In the Matter of  
COMMONWEALTH EDISON COMPANY  
(Byron Station, Units 1 and 2)  
Docket Nos. 50-454 and 50-455

REPORT TO THE GOVERNMENT OF YUGOSLAVIA

Advisory Services  
Steam Generator Vibration Problems

ADVISORY MISSION TO YUGOSLAVIA

KRSKO FEEDWATER BYPASS SYSTEM : MODIFIED ARRANGEMENT

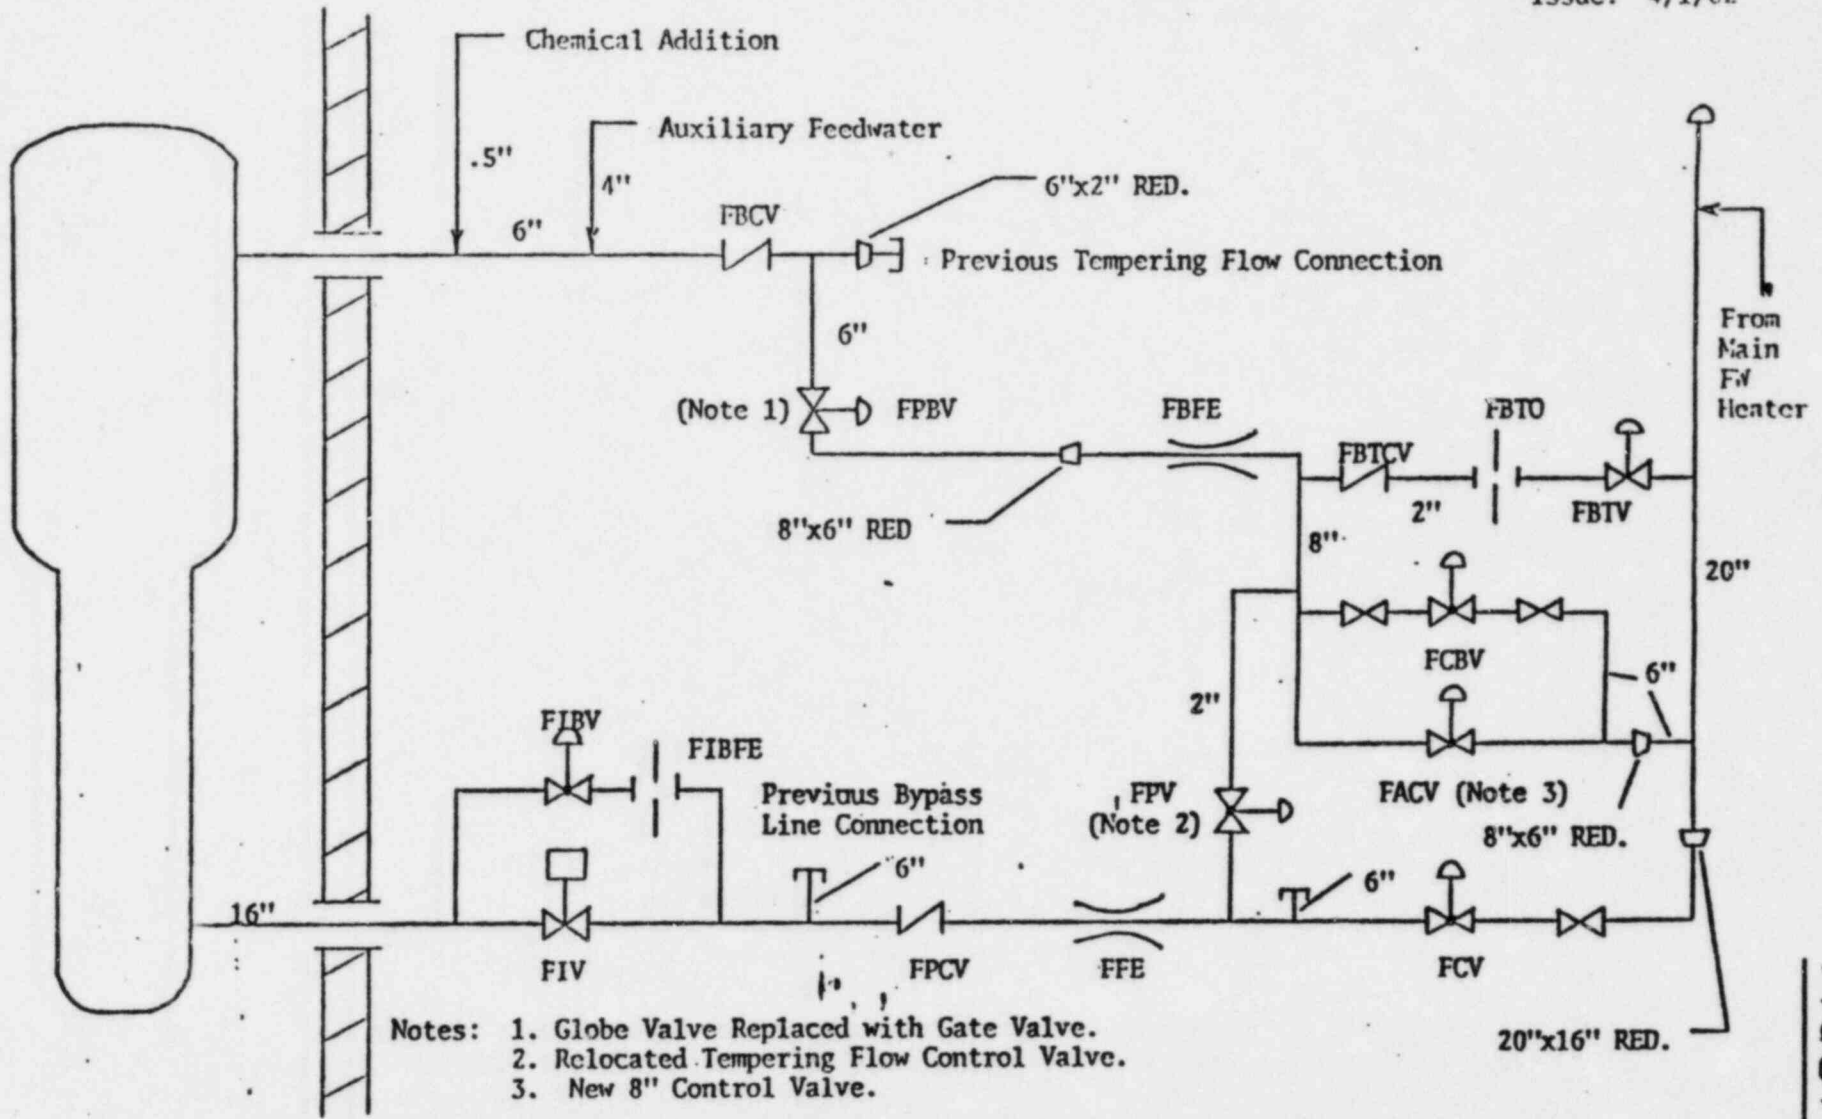
The proposed modification of the feedwater system is extensive. The Mission recommends that the independent design reviews of this modification be completed on a timely basis. The review should include mechanical and thermo-hydraulic aspects as well as those relating to control and protection system modifications.

With regard to the steam generators, the Mission identified the concern of vibration of the intermediate deck plate due to the increased auxiliary nozzle flow injection.

Reduced flow through the preheater section (from 100% to 70% flow) may lead to increased steam formation at the bottom part of the preheater. The Mission was informed that the vendor did not expect any water hammer hazard to develop as a result of increased steam generation. A criterion was quoted under which no net steam formation should occur in the four first passes of the preheater. This criterion would also be met at the reduced flow operation.

The Mission recommends that careful consideration be given to ensure that there would be no adverse interactions between the control and safety features of the feedwater system.

The proposed modifications include changes to the reactor protection system, the feedwater control system and the auxiliary control system. The effects of such changes with regard to possible adverse system interactions should be fully understood, especially under transient and accident modes and at various flow conditions. Of particular concern would be the effect of the proposed changes on overcooling transients, transients involving switch-overs (e.g. load rejections), and other such events included in Chapter 15 FSAR analyses. Further, no adverse failures in the control system should preclude the operation of any required safety function.
